Economic Commission for Europe**Inland Transport Committee****World Forum for Harmonization of Vehicle Regulations****Working Party on Passive Safety****Fiftieth session**

Draft Regulation on pedestrian safety**Proposal for the 01 series of amendments to the draft Regulation****Submitted by the expert from Japan ***

This proposal was prepared by the expert from Japan to introduce editorial corrections to the text of the proposal for the 01 series of amendments to the draft Regulation (ECE/TRANS/WP.29/GRSP/2011/14). It is based on a document without a symbol (GRSP-49-14) distributed during the forty-ninth session of the Working Party on Passive Safety (GRSP) (see ECE/TRANS/GRSP/49, para. 38). The modifications to the proposal of 01 series of amendments to the Regulation on pedestrian safety (ECE/TRANS/WP.29/GRSP/2011/14) and to the current text of the draft Regulation (ECE/TRANS/WP.29/2010/127) are marked in bold for new or strikethrough for deleted characters.

Lower legform II: instrument locations

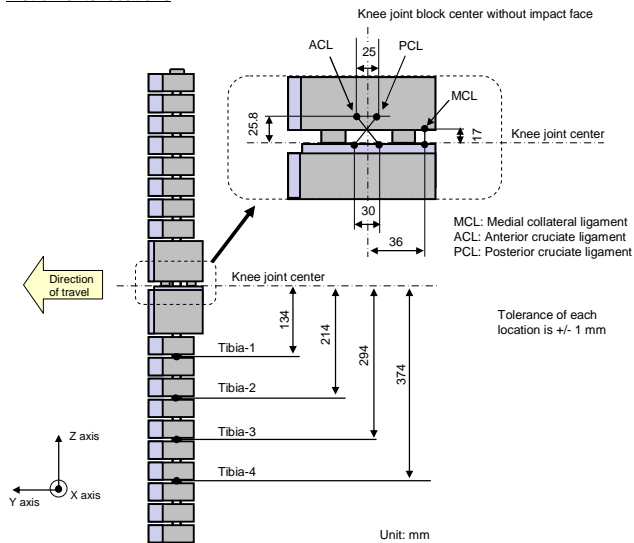
Annex 4, Figure 5, amend to read:

Lower legform II test set-up for knee joint in static certification test (see paragraph 1.2.5.)

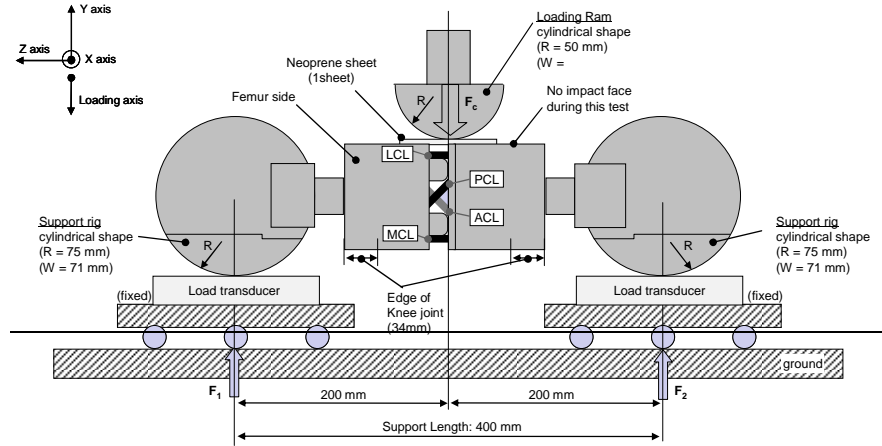
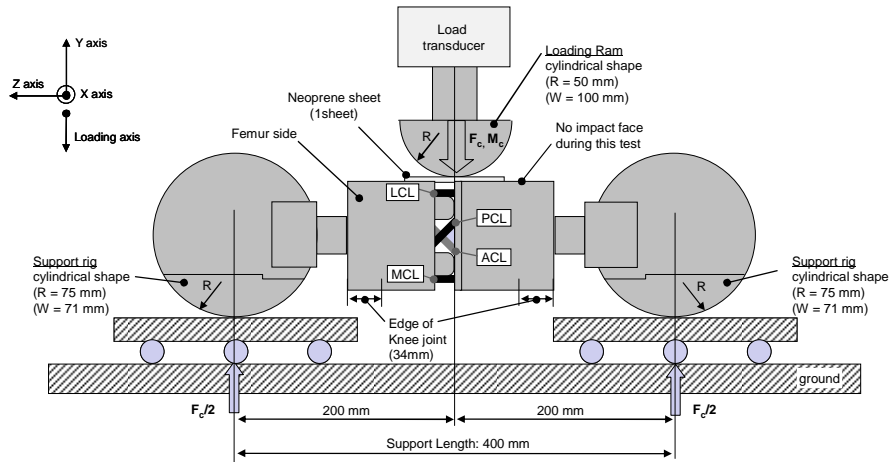
Figure 5., amend to read:

F_c : External loading force at center of knee joint
 F_s : Support force of Femur side of knee
 M_s : Bending moment at Knee joint center (Nm) = $F_s (N) \times 0.2 (m)$
 R : Radius, W : Width along to the side axis

F_c : External loading force at center of knee joint
 M_c : Moment center (Nm) = $F_c/2 (N) \times 0.2 (m)$
 R : Radius, W : Width along to the side axis
